SUBJECT: Removing CB Band From R-599A/D

**DATE** 3-15-78

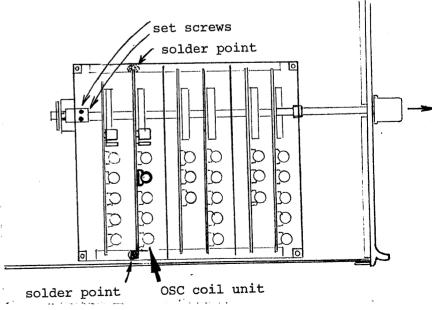
One of the items in the FCC's expansion of the CB band to 40 channels was to require all receivers that have a specific CB or 11 meter band be type accepted. The R-599A and R-599D receivers have not been type accepted and we do not plan to have this done as they are designed for the ham bands. We have therefore removed the CB position from the current production of R-599D receivers and this band position is now labeled AUX.

This ruling also applies to any used R-599A or R-599D receiver you may have in stock. The following instructions are for removing the CB band. This will satisfy the FCC and make the receiver saleable.

- 1. Remove top cover.
- 2. Remove bottom cover.
- 3. Remove shield plate from coil pack.
- 4. Set band switch to 14MHz.
- 5. Remove the black wire from the OSC Coil Unit. (This wire is on the top side.)
- 6. Loosen screws on shaft coupling and slide shaft out about 2 inches.
- 7. Unsolder the OSC Coil Unit from the mounting bracket and remove it from the coil pack.
- 8. Unsolder and remove the CB coil and crystal.
- 9. Replace the OSC Coil Unit and solder it in.
- 10. Slide the band switch shaft in place, making sure that each wafer is properly indexed.
- 11. Resolder the black wire to the OSC Coil Unit.
- 12. Replace all covers.
- 13. Check for proper operation.
